RACE KIT

Cunningham Downhaul System / Boom Vang

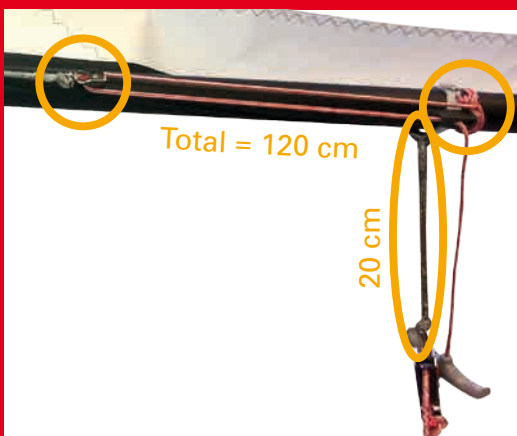
A) Add to the existing Cunningham Downhaul System :
1 x extra single pulley + extra rope 40 cm length.
Cunningham downhaul rope lengthened to have a total length of 360 cm (320 cm original + 40 cm extra).
Rig the system as shown in the photo to give an extra 2 pulleys leverage on the Cunningham System.
